From: Kristen Kapelanski, AICP  
 Date: 10/4/2018  
 Re: **Leader Dogs Parking Addition (City File #90-262.4)**  
**Site Plan - Planning Review #2**

From: Nancy McLaughlin  
Date: 10/8/18  
Re: File No.: 90-262.4  
Project: Leader Dogs Parking Addition Review #2  
Parcel No: 70-15-23-101-028  
Applicant: Chris Bearup, Leader Dogs

To: Kristen Kapelanski  
From: Matt Einheuser  
Date: September 24, 2018  
Re: Leader Dogs Parking Addition  
Review #2  
File #90-262.4

From: Jason Boughton, AC, Engineering Utilities Coordinator  
To: Kristen Kapelanski, AICP, Manager of Planning & Development  
Date: September 27, 2018  
Re: Leader Dogs Parking Lot Addition, City File #90-262.4, Section 23  
Site Plan Review #2

**CITY OF ROCHESTER HILLS**  
STANDARD DETAIL FOR:  
**Sight Distance Roadways**

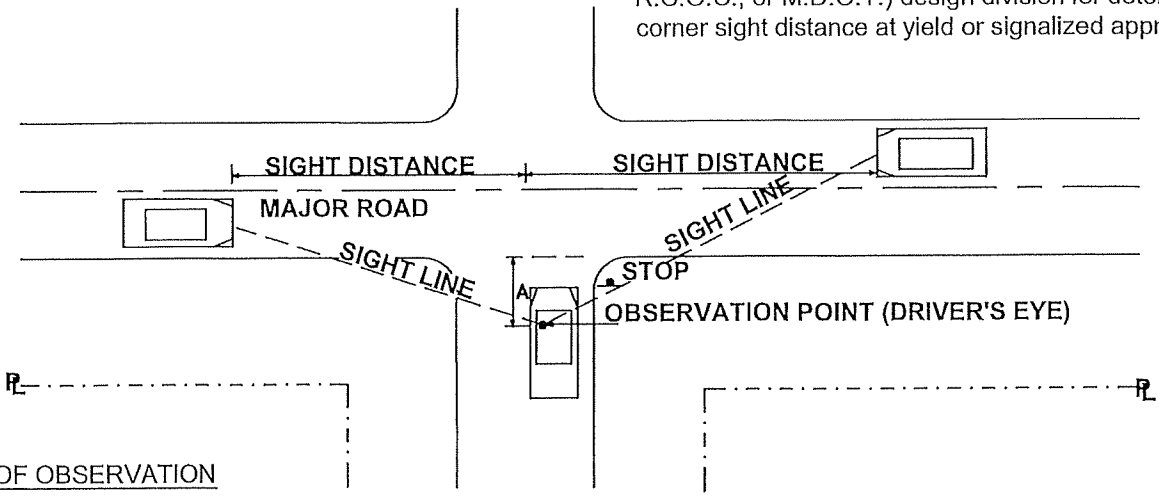
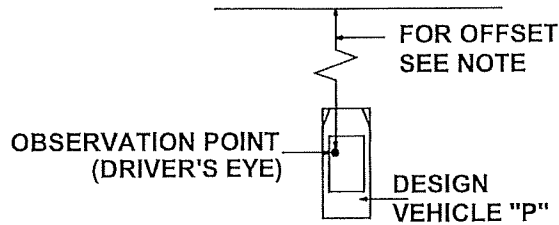
1. Add a note on plans that a City right-of-way (ROW) use permit is required for the approach work within Rainer Road ROW.
2. Add a note on plans a RCOC ROW use permit is required for the removal of the drive approach on Avon Road ROW.
3. On sheet 07, landscape plan, please draw the sight distance lines per previously submitted details. The triangles drawn are not necessary.
